Produktänderungsinformation

## Produktänderungsinformation

**Ausgabedatum:** 2025-01  
**Betroffene Artikel:** RM45, RM46, RM29, RM66, RM84  
**Beschreibung der Änderung:** Gehäuse

**Issue date:** 2025-01  
**Affected products:** RM45, RM46, RM29, RM66, RM84  
**Object of change:** change of case

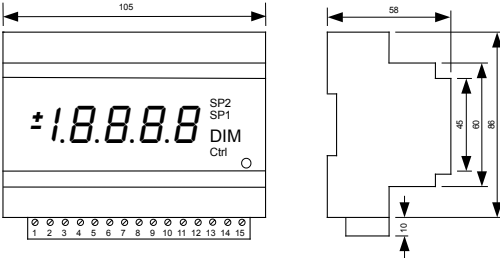
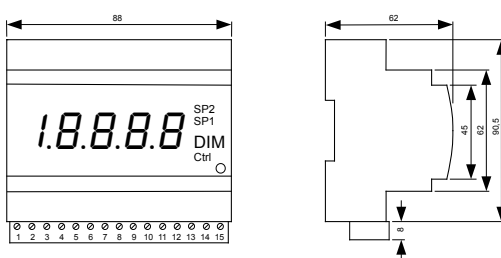
Parameter	alt	neu
Gehäusematerial	Noryl/Lexan, UL 94 V-0	PC/ABS, UL 94 V-0
Abmessungen	 	 
V.24 Stecker	RJ-45	15 pol. SUB-D Buchse
Isolation V.24 zu Analogausgang	keine galv. Isolation, GND ist nicht auf Potential von Analog OUT-	4-Wege-Trennung (Versorgung, Messkreis, Analog OUT, V.24)

Parameter	old	new
Case material	Noryl/Lexan, UL 94 V-0	PC/ABS, UL 94 V-0
Dimensions		
V.24 connector	RJ-45	15 pin SUB-D female
Isolation V.24 to analog out	no galvanic isolation, GND is not of same level as analog OUT-	4-way-isolation (supply, measure input, analog OUT, V.24)

**Änderung Datenblatt:** Januar 2025  
**Lieferung ab:** 2025-05  
**Identifikation:** Durchgängig rote Displayfront

**Change of data sheet:** January 2025  
**Effective from:** 2025-05  
**Identification:** All-red display front
